USSN 09/457,434
Atty. Docket No. HEN-9910

REMARKS

**MARKED-UP FIGURE SHOWING CHANGES MADE ACCOMPANYING RESPONSE TO OFFICE
ACTION FOR USSN 09/457,434**

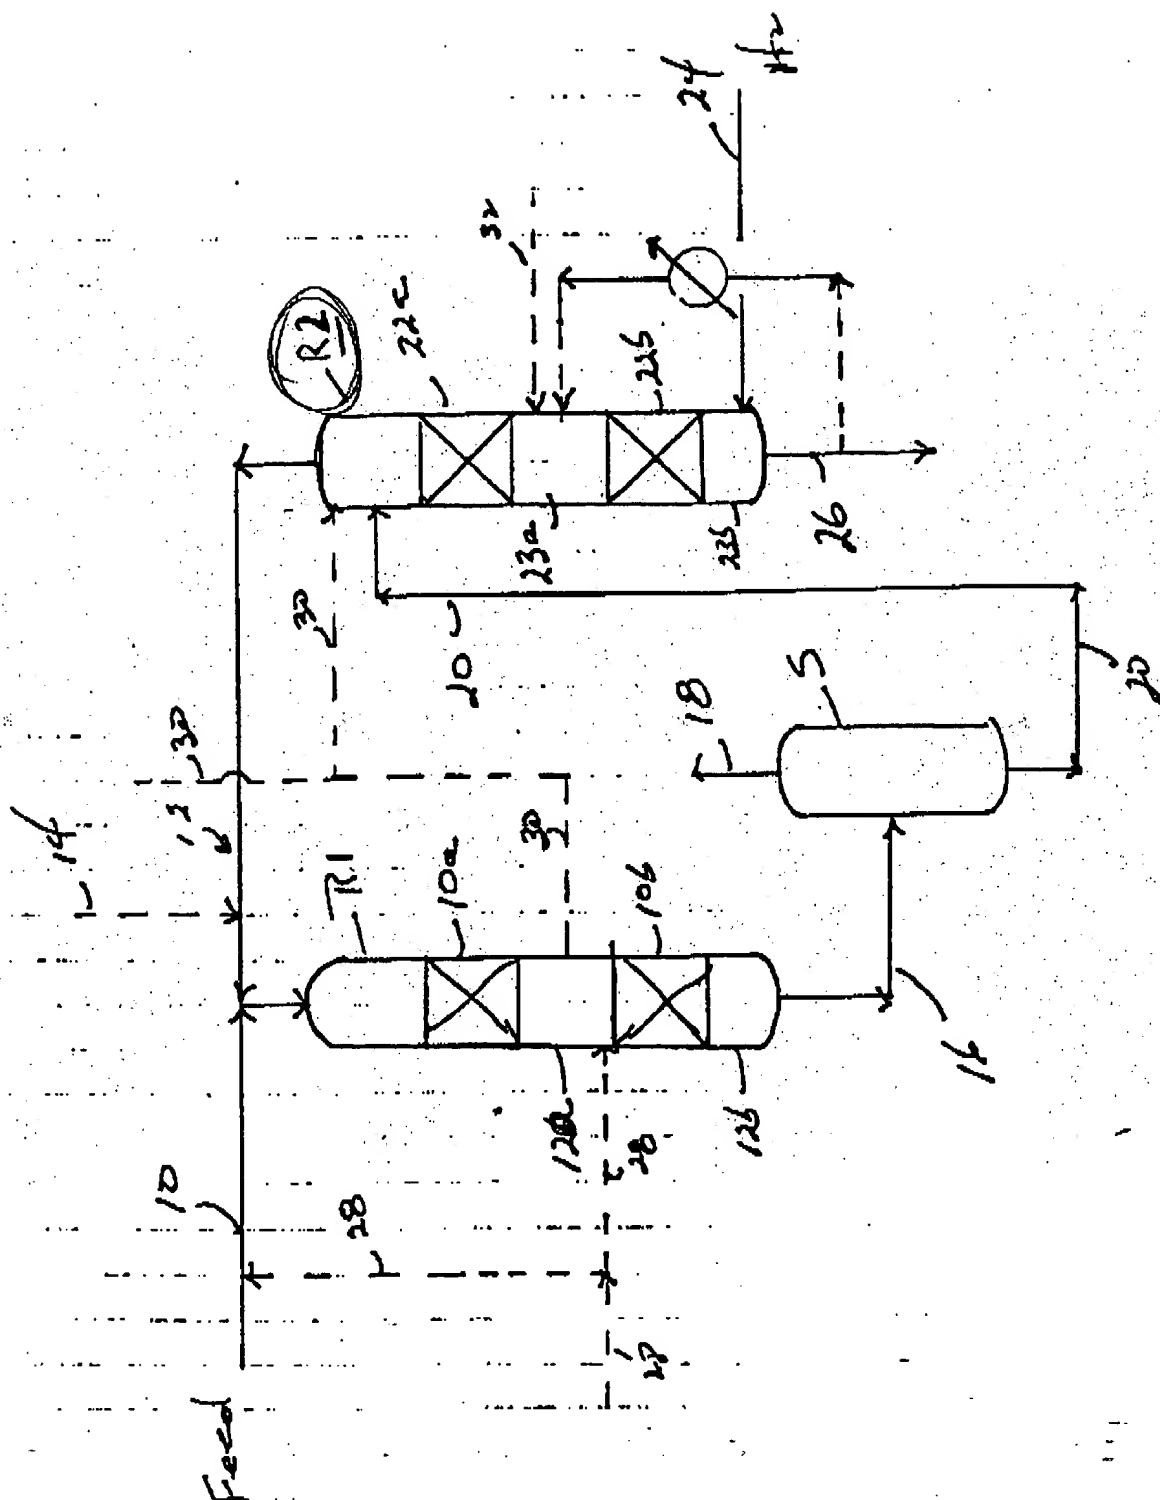
The Figure corresponding to the instant specification has also been amended according to the Examiner's suggestions. Namely, the reference number "R2" has been added to refer to the second reaction stage. No New matter was added.

The Examiner points out that the specification on page 8 teaches that the vapor product stream is collected via overhead line 20 when the drawing gives this line

reference numeral "18". The Examiner also points out typographical errors in the specification.

Page 8 of the specification has been amended according to the Examiner's suggestions. Namely, the second "is" as it appears in the last full sentence of page 8 has been deleted. Also, the reference to the overhead vapor product stream as line "20" has been amended to refer to this stream with reference numeral "18"; this overhead vapor product stream is denoted as such in the attached Figure. No New matter was added.

A marked up version of the Figure showing the changes made and a corrected formal version of the Figure are attached hereto.
